ENVIRONMENTAL HEALTH SERVICES  
ENVIRONMENTAL PROTECTION  
1131 Harbor Bay Parkway, Suite 250  
Alameda, CA 94502-6577  
FAX (510) 337-9335  
(510) 567-6700

Subject: Conditional Work Plan Approval and Technical Report Request for Fuel Leak Case No. RO0000159 and Geotracker Global ID T0600100274, Mobil, 3635 13<sup>th</sup> Avenue, Oakland, CA

**WELL SURVEY MAP**  
**CHEVRON SERVICE STATION 9-6991**  
**2920 CASTRO VALLEY BOULEVARD**  
*Castro Valley, California*

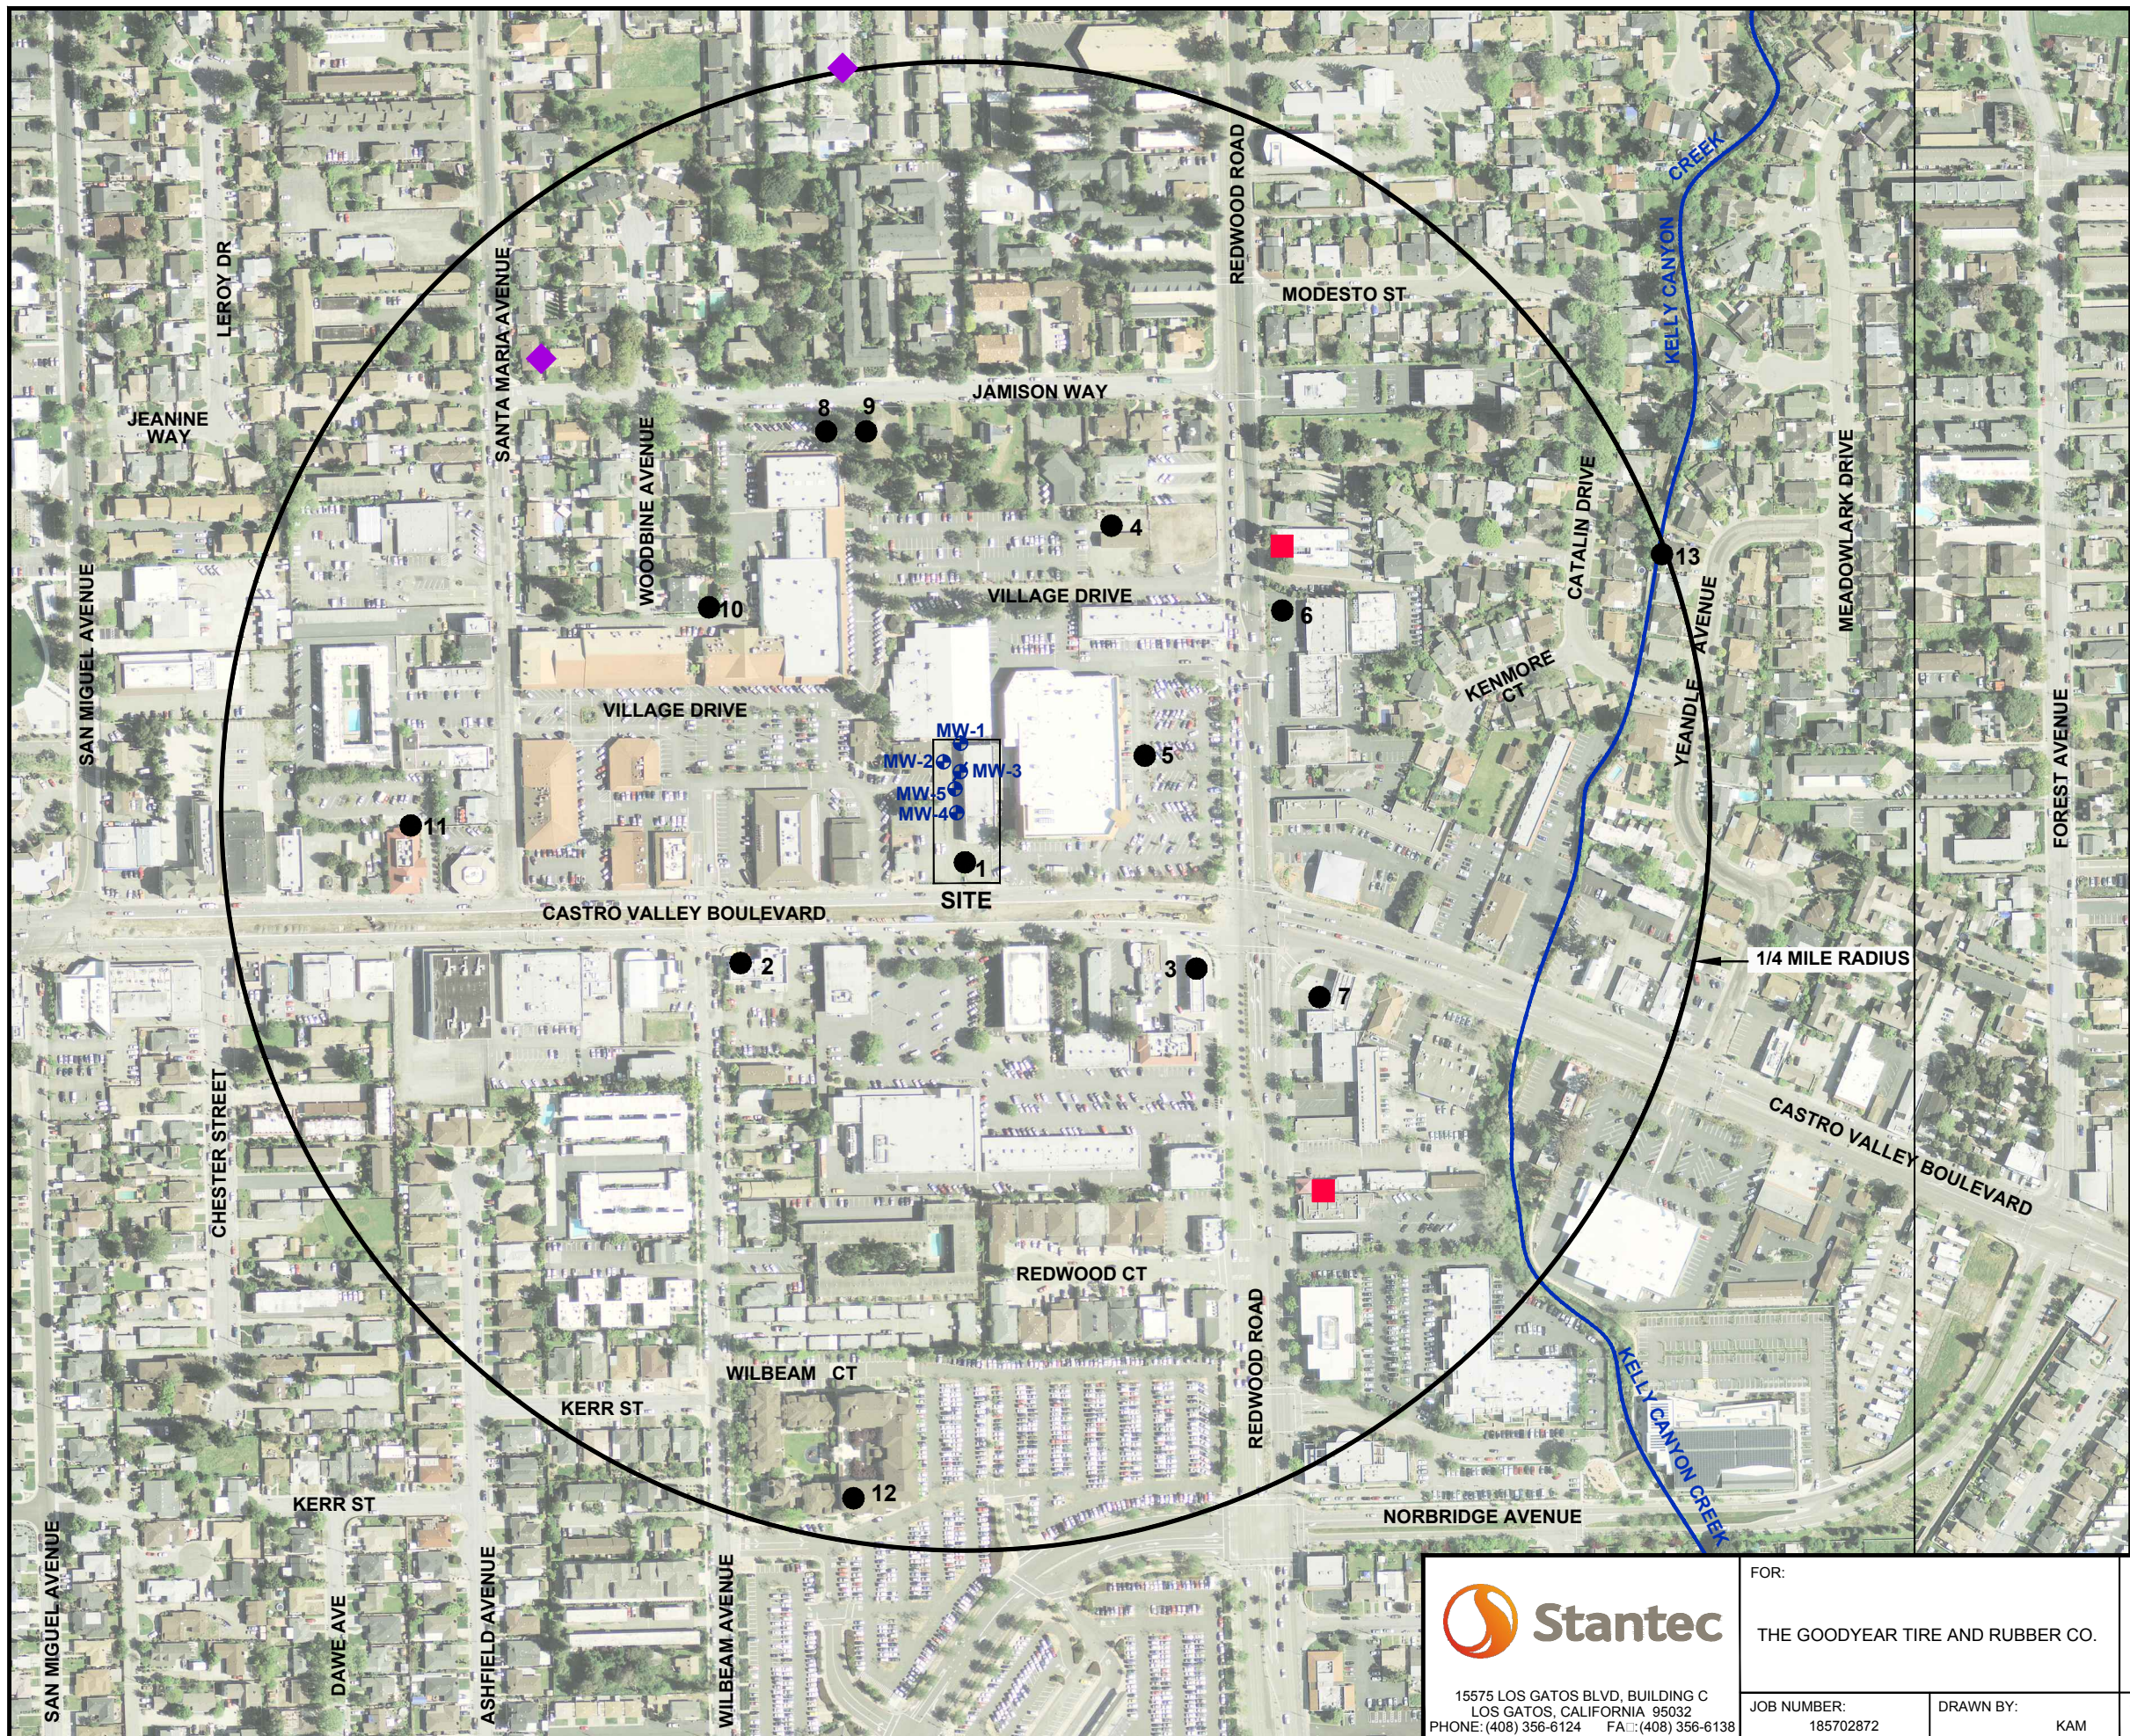
- a. Please perform a well survey and sensitive receptor survey, as originally requested in the October 17, 2014 Directive Letter, to determine if sensitive receptors are present within a radius of 1,500 feet of the site. ACDEH requests review of both Alameda County Public Works Agency (ACPWA) and Department of Water Resources (DWR) well data sources for a complete inventory of vicinity water supply wells. ACDEH requests the identification and location on a site vicinity figure all active, inactive, standby, decommissioned (sealed with concrete), unrecorded, and abandoned (improperly decommissioned or lost) wells including irrigation, water supply, industrial, dewatering, and cathodic protection wells within a 1,500-foot radius of the site. Please provide an aerial photograph-based figure indicating the numbered well locations and a table listing the numbered well locations, well owner, well address, total well depth, date installed, distance and direction for site in feet, and well use as shown in the Well Survey Map and Well Survey Results Table provided in Attachment 2.

Figure 2  
 SITE PLAN  
 CHEVRON SERVICE STATION 90076  
 4265 FOOTHILL BOULEVARD  
 Oakland, California

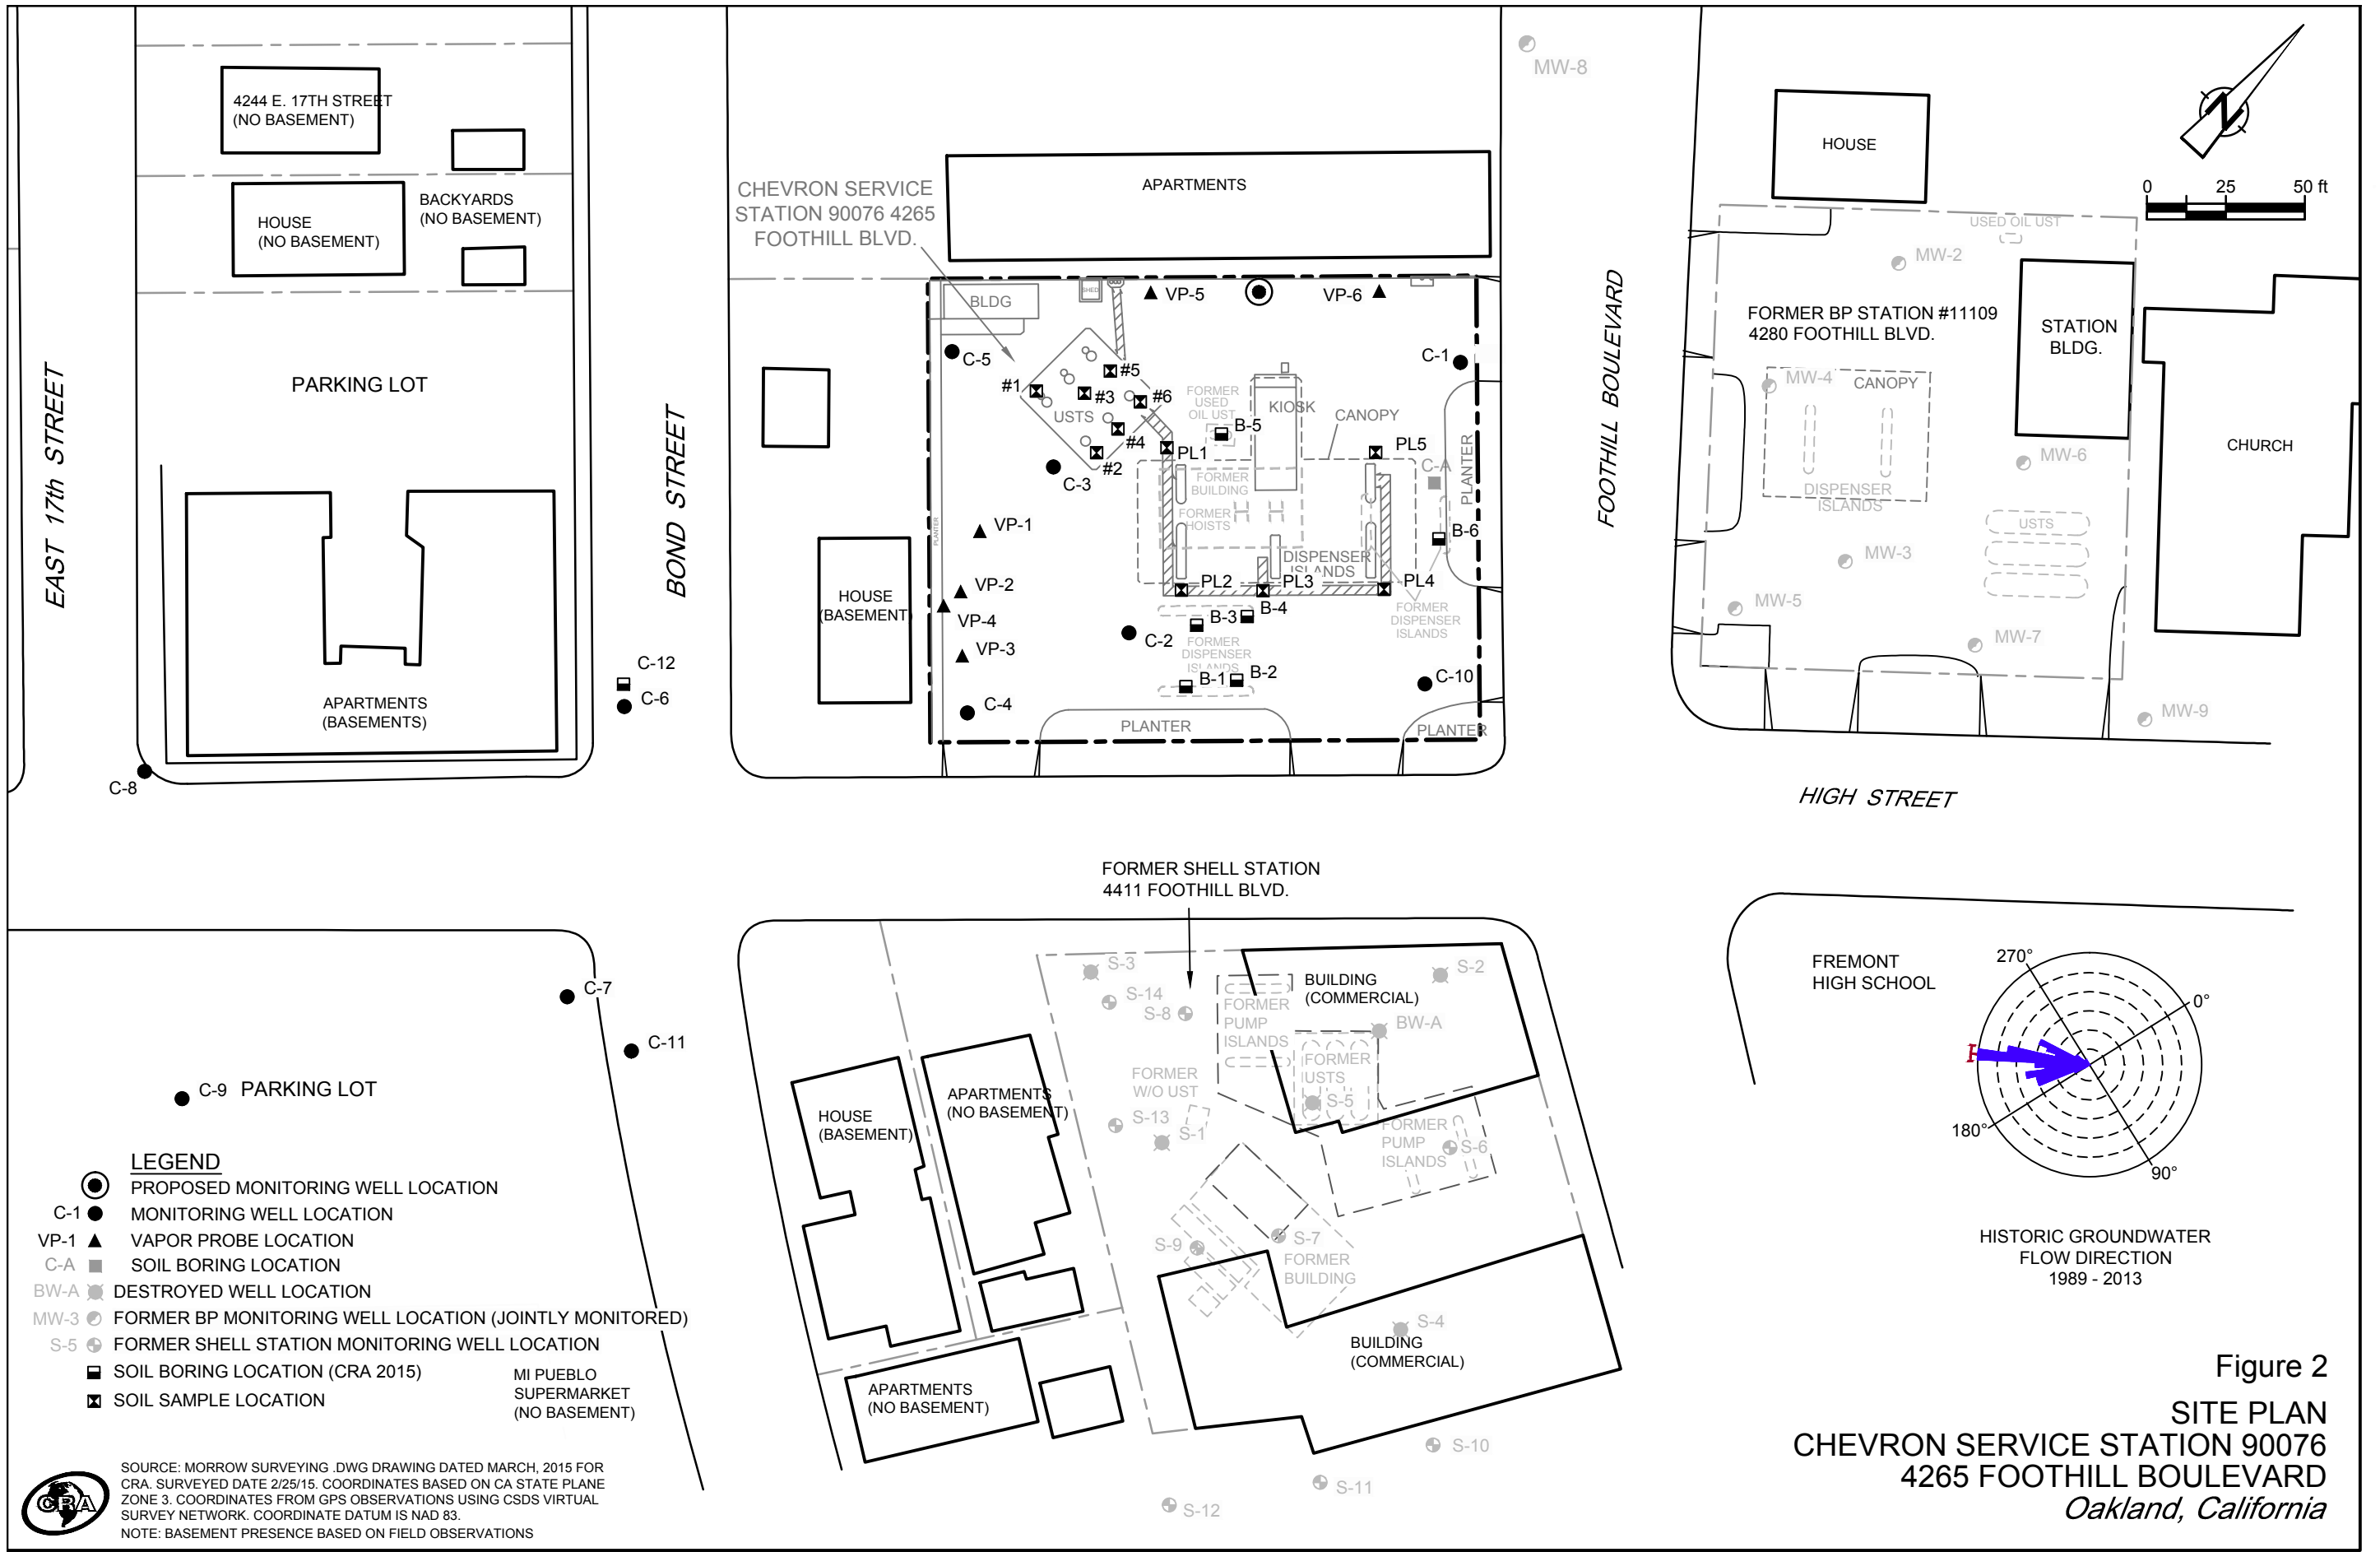
- c. Please identify on the aerial photograph-based site vicinity figure buildings with basements, half-basements, or potential dewatering structures (such as sump pumps) as shown in the Figure 2, *Site Plan Chevron Service Station 90076 4265 Foothill Blvd., Oakland, CA* provided in Attachment 2. These structures have the potential to bring contaminated groundwater to the surface for discharge to the street or storm drain.
